LB-8 MAGNET VALVE PORTIONS

Transient Voltage Suppressor Upgrade

NOVEMBER, 1997

Figure 1 - LB-8 Magnet Valve Portion with Transient Voltage Suppressor

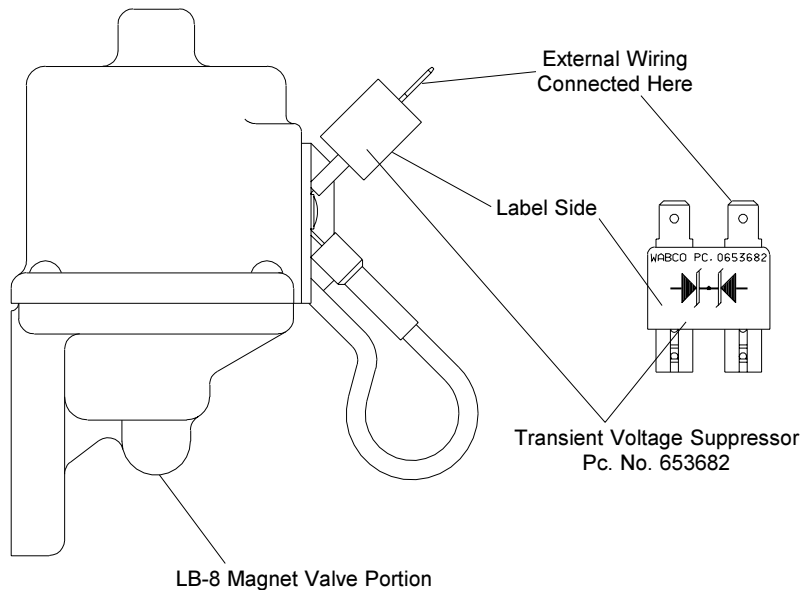
Wabtec has developed an improved **Transient Voltage Suppressor, Pc. No. 653682**, for use on the LB-8 Magnet Valve Portions. This new device is being issued as an alternate standard, and can be substituted in place of standard suppression diode, Pc. No. 303894, where a higher level of protection against voltage transients is desired.

Figure 1 depicts proper installation of the Wabtec Transient Voltage Suppressor to the LB-8 Magnet Valve Portion.
